City of Boise ADA  
Assessment

# Appendix A - Public Works Farm Office Shop Building

Report #TO20-B010

**Location:** AED in Public Area  
**Schedule:** 2021  
**Estimated Cost:** \$100.00

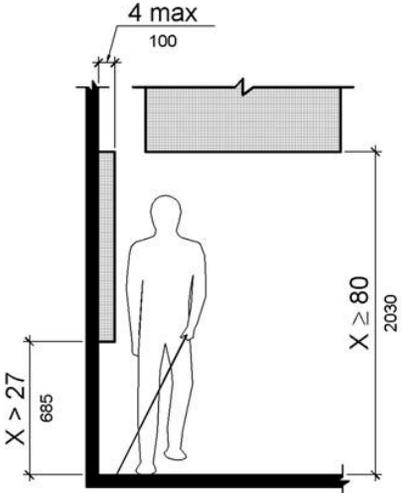
**2010 ADA Standards for Accessible Design Codes: §307.2**  
The AED protrudes 6" into the circulation space at 46" above the floor.

Recess the AED so it protrudes a maximum of 4", lower it so the bottom edge is 27" maximum above the floor, or place a cane detectable object beneath it.

**Location:** Back Office TV  
**Schedule:** 2021  
**Estimated Cost:** \$100.00

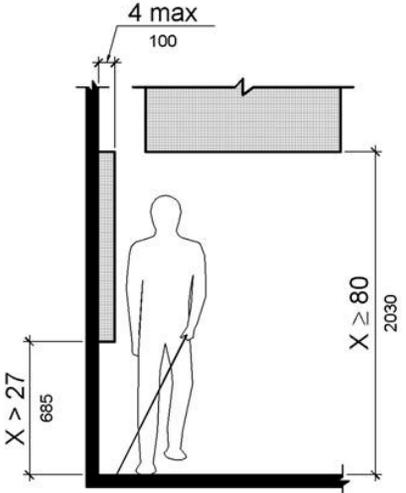
**2010 ADA Standards for Accessible Design Codes: §307.2**  
The TV protrudes 9.5" into the circulation space at 71" above the floor.

Recess the TV so it protrudes a maximum of 4", raise it so the bottom edge is 80" maximum above the floor, or place a cane detectable object beneath it.

**Location:** Entrance  
**Schedule:** 2021  
**Estimated Cost:** \$100.00

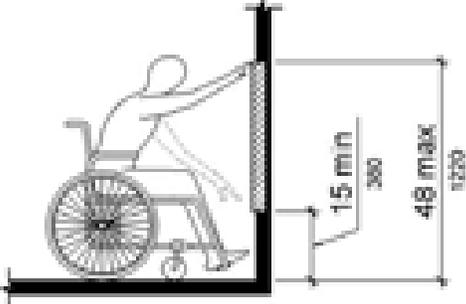
**2010 ADA Standards for Accessible Design Codes: §308.2.1**  
The push button is outside of the unobstructed forward reach range at 50" above the floor.

Lower the push button by at least 2" to meet the accessible reach range of 15" minimum and 48" maximum above the floor.

**Location:** Kestrel Conference Room  
**Schedule:** 2021  
**Estimated Cost:** \$100.00

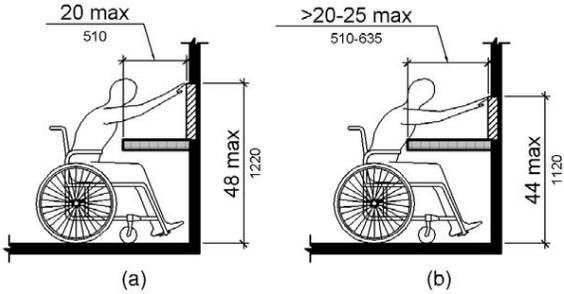
**2010 ADA Standards for Accessible Design Codes: §308.2.2**  
The paper towel dispenser is outside of the obstructed forward reach range at 69" above the floor.

Lower the paper towel dispenser by 21" to meet the accessible reach range of 44" maximum above the floor.

**Location:** Kestrel Conference Room  
**Schedule:** 2022  
**Estimated Cost:** \$1,000.00

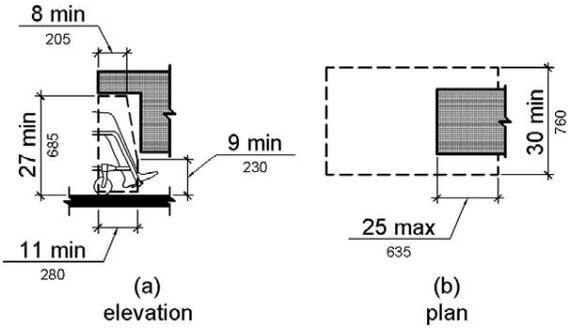
**2010 ADA Standards for Accessible Design Codes: §306.3.3**  
There is no knee clearance underneath the counter.

Provide knee clearance underneath the counter at the sink that is a minimum of 11" deep at 9" above the floor and 8" deep at 27" above the floor.

**Location:** Men's Locker Room  
**Schedule:** 2021  
**Estimated Cost:** \$100.00

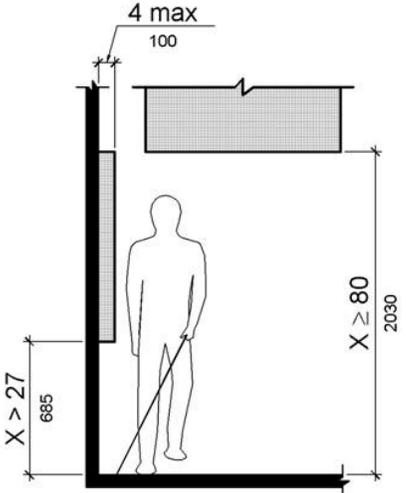
**2010 ADA Standards for Accessible Design Codes: §307.2**  
The shower curtain rod is 75" above the floor.

Raise the shower curtain rod by 5" so it is 80" above the floor.

**Location:** Men's Locker Room  
**Schedule:** 2021  
**Estimated Cost:** \$100.00

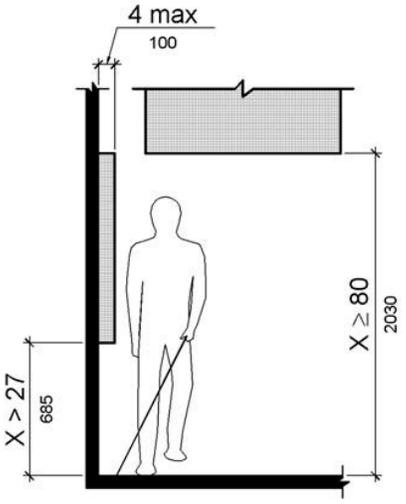
**2010 ADA Standards for Accessible Design Codes: §307.2, §308.2.1**  
The paper towel dispenser is outside of the unobstructed forward reach range at 52" above the floor. The paper towel dispenser protrudes 8" into the circulation space at 52" above the floor.

Lower the paper towel dispenser by 4" to meet the accessible reach range of 48" maximum above the floor.  
Recess the paper towel dispenser so it protrudes a maximum of 4" or place a cane detectable object beneath it.

**Location:** Men's Locker Room  
**Schedule:** 2021  
**Estimated Cost:** \$200.00

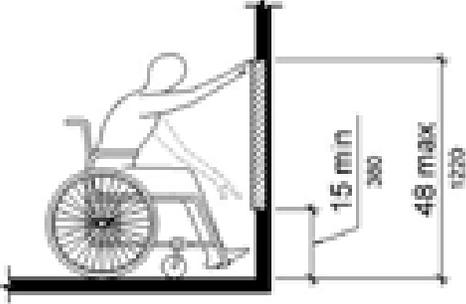
**2010 ADA Standards for Accessible Design Codes: §308.2.1**  
The shelves are outside of the unobstructed forward reach range at 59.5" above the floor.

Lower the shelves by 11.5" to meet the accessible reach range of 48" maximum above the floor.

**Location:** Men's Locker Room  
**Schedule:** 2021  
**Estimated Cost:** \$500.00

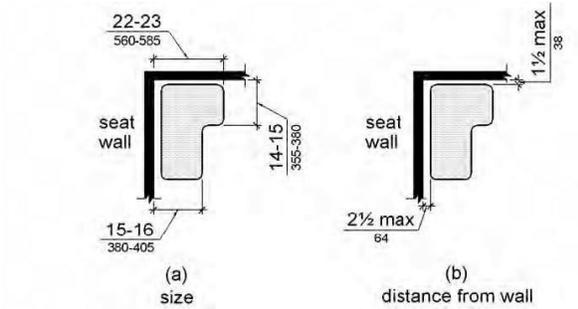
**2010 ADA Standards for Accessible Design Codes: §610.3.2**  
The L-shaped shower seat does not meet the minimum requirements with a long side depth of 21" and a short side depth of 13.5".

Replace the L-shaped shower seat with one that has a long side depth from the seat wall to the front edge of 22" minimum and 23" maximum and a short side depth from the seat wall to the front edge 15" minimum and 16" maximum.

**Location:** Men's Locker Room  
**Schedule:** 2022  
**Estimated Cost:** \$1,000.00

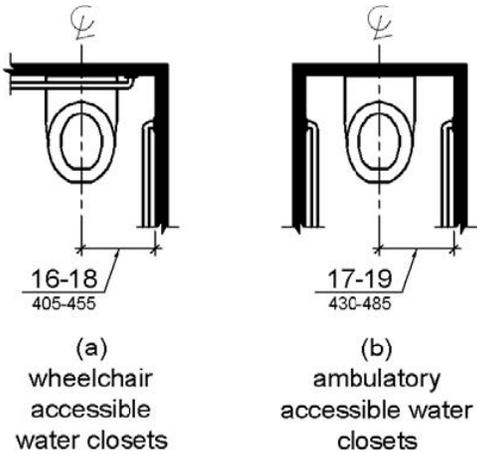
**2010 ADA Standards for Accessible Design Codes: §604.2**  
The toilet is located 18.5" from the sidewall.

Reposition the toilet to be within 16" minimum and 18" maximum from the sidewall.

**Location:** Men's Locker Room  
**Schedule:** 2022  
**Estimated Cost:** \$1,000.00

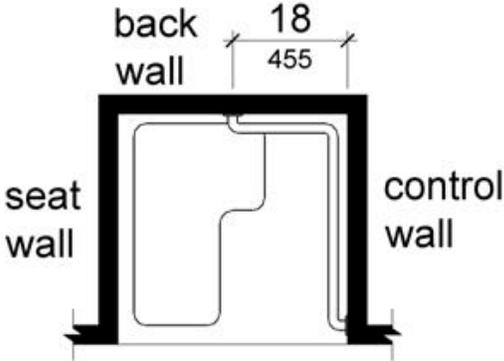
**2010 ADA Standards for Accessible Design Codes: §608.3.1**  
The control wall grab bar is 16" long.

Replace the control wall grab bar with one that is a minimum of 36" long, which is the full length of the control wall for a transfer type shower.

**Location:** Men's Locker Room  
**Schedule:** 2022  
**Estimated Cost:** \$1,000.00

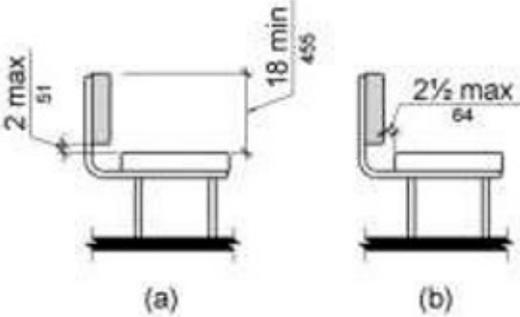
**2010 ADA Standards for Accessible Design Codes: §903.4**  
The benches do not have back support.

Provide back support that is 42" long minimum and extends from a point 2" maximum above the seat surface to a point 18" minimum above the seat surface.  
Back support shall be 2½" maximum from the rear edge of the seat measured horizontally.

**Location:** Men's Locker Room  
**Schedule:** 2022  
**Estimated Cost:** \$1,000.00

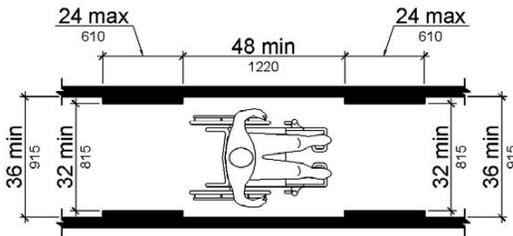
The bench does not have back support.

There is not a clear 36" width for wheelchairs to pass. The width is 34" between the bench and lockers.

Provide back support that is 42" long minimum and extends from a point 2" maximum above the seat surface to a point 18" minimum above the seat surface.

Back support shall be 2½" maximum from the rear edge of the seat measured horizontally. This can be achieved by relocating one bench to utilize a nearby wall as back support. Shift the bench 2" away from the lockers.

**Location:** Men's Locker Room  
**Schedule:** 2021  
**Estimated Cost:** \$1,500.00

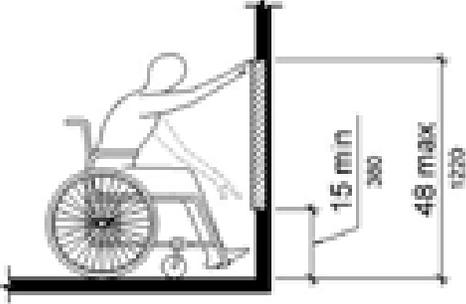
**2010 ADA Standards for Accessible Design Codes: §308.2.1**  
The lockers are outside of the unobstructed forward reach range at 57" above the floor.

Lower 5% of the lockers by 9" to meet the accessible reach range of 15" minimum and 48" maximum above the floor.

**Location:** Parking  
**Schedule:** 2021  
**Estimated Cost:** \$1,000.00

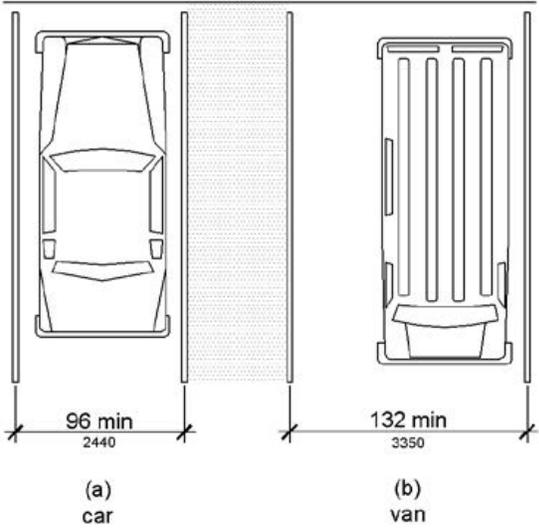
**2010 ADA Standards for Accessible Design Codes: §502.2, §208.2.4**  
 There is only one space and it is not van accessible. The accessible parking space is not of sufficient width at 108" wide.

Expand the accessible parking space to a minimum of 132" wide. Add a "van accessible" parking sign at a minimum height of 60" above the ground. Ensure the access aisle is a minimum width of 60".

**Location:** Public Restroom  
**Schedule:** 2022  
**Estimated Cost:** \$1,000.00

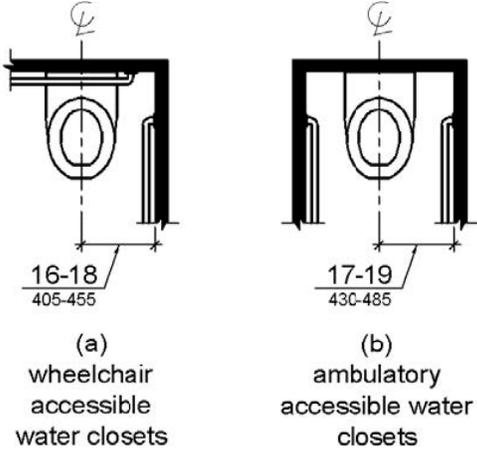
**2010 ADA Standards for Accessible Design Codes: §604.2**  
The toilet is located 18.5" from the sidewall.

Reposition the toilet to be within 16" minimum and 18" maximum from the sidewall.

**Location:** Women's Locker Room  
**Schedule:** 2021  
**Estimated Cost:** \$100.00

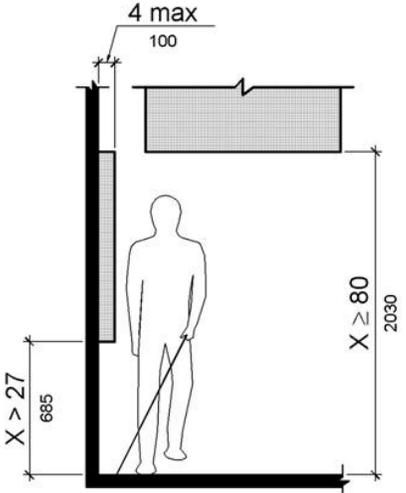
**2010 ADA Standards for Accessible Design Codes: §307.2**  
The shower curtain rod is 74" above the floor.

Raise the shower curtain rod by 6" so it is 80" above the floor.

**Location:** Women's Locker Room  
**Schedule:** 2021  
**Estimated Cost:** \$100.00

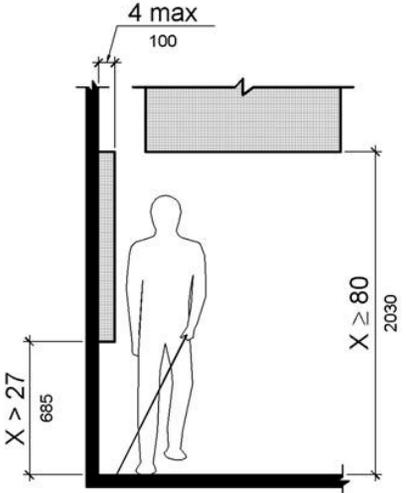
**2010 ADA Standards for Accessible Design Codes: §307.2**  
The paper towel dispenser protrudes 8" into the circulation space at 41" above the floor.

Recess the paper towel dispenser so it protrudes a maximum of 4" or ensure the detectable object remains beneath it at all times.

**Location:** Women's Locker Room  
**Schedule:** 2021  
**Estimated Cost:** \$100.00

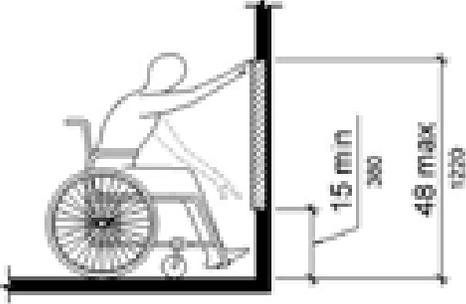
**2010 ADA Standards for Accessible Design Codes: §308.2.1**  
The corner shelves are outside of the unobstructed forward reach range at 59" above the floor.

Lower the corner shelves by 11" to meet the accessible reach range of 48" maximum above the floor.

**Location:** Women's Locker Room  
**Schedule:** 2021  
**Estimated Cost:** \$500.00

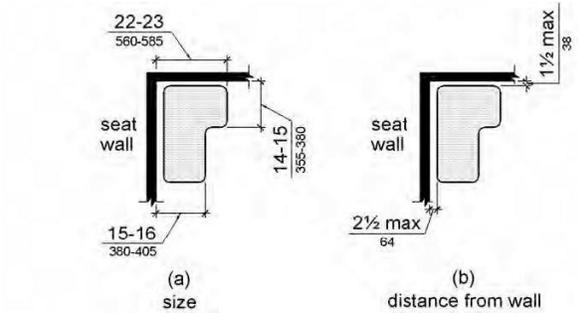
**2010 ADA Standards for Accessible Design Codes: §610.3.2**  
The L-shaped shower seat does not meet the minimum requirements with a long side depth of 21" and a short side depth of 13".

Replace the L-shaped shower seat with one that has a long side depth from the seat wall to the front edge of 22" minimum and 23" maximum and a short side depth from the seat wall to the front edge 15" minimum and 16" maximum.

**Location:** Women's Locker Room  
**Schedule:** 2021  
**Estimated Cost:** \$500.00

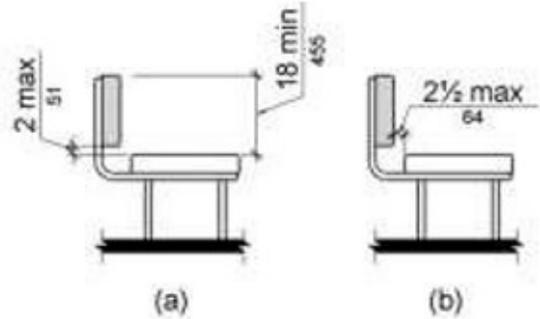
**2010 ADA Standards for Accessible Design Codes: §903.4**  
The bench does not have back support.

Provide back support that is 42" long minimum and extends from a point 2" maximum above the seat surface to a point 18" minimum above the seat surface.  
Back support shall be 2.5" maximum from the rear edge of the seat measured horizontally.

**Location:** Women's Locker Room  
**Schedule:** 2021  
**Estimated Cost:** \$500.00

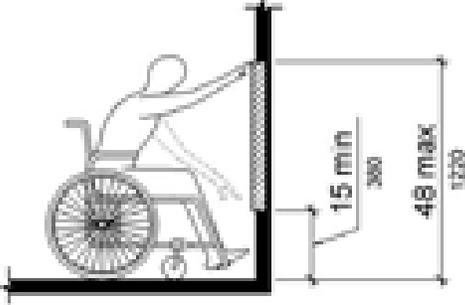
**2010 ADA Standards for Accessible Design Codes: §308.2.1**  
The lockers and locker curtain rods are outside of the unobstructed forward reach range at 63" and 57" above the floor.

Lower 5% of the lockers and locker curtain rods by 15" and 9" to meet the accessible reach range of 15" minimum and 48" maximum above the floor.

**Location:** Women's Locker Room  
**Schedule:** 2022  
**Estimated Cost:** \$1,000.00

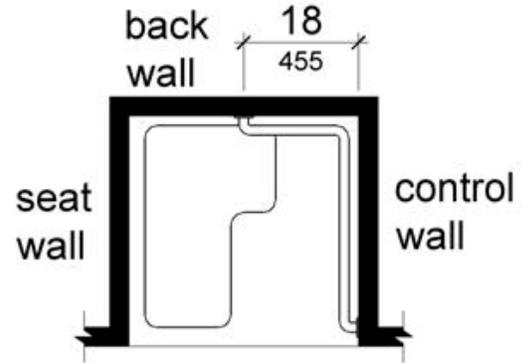
**2010 ADA Standards for Accessible Design Codes: §608.3.1**  
The control wall grab bar is 16" long.

Replace the control wall grab bar with one that is a minimum of 36" long, which is the full length of the control wall for a transfer type shower.

**Location:** Women's Locker Room  
**Schedule:** 2021  
**Estimated Cost:** \$1,500.00

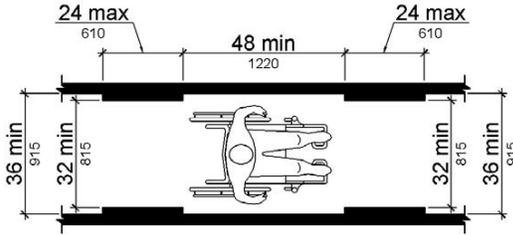
The bench does not have back support. There is not a clear 36" width for wheelchairs to pass between the bench and lockers and the shower.

The width is 31" between the bench and lockers and 25" between the bench and shower.

Provide back support that is 42" long minimum and extends from a point 2" maximum above the seat surface to a point 18" minimum above the seat surface. Shift the bench 11" away from the shower and 5" away from the lockers.

Back support shall be 2½" maximum from the rear edge of the seat measured horizontally. This can be achieved by relocating one bench to utilize a nearby wall as back support.
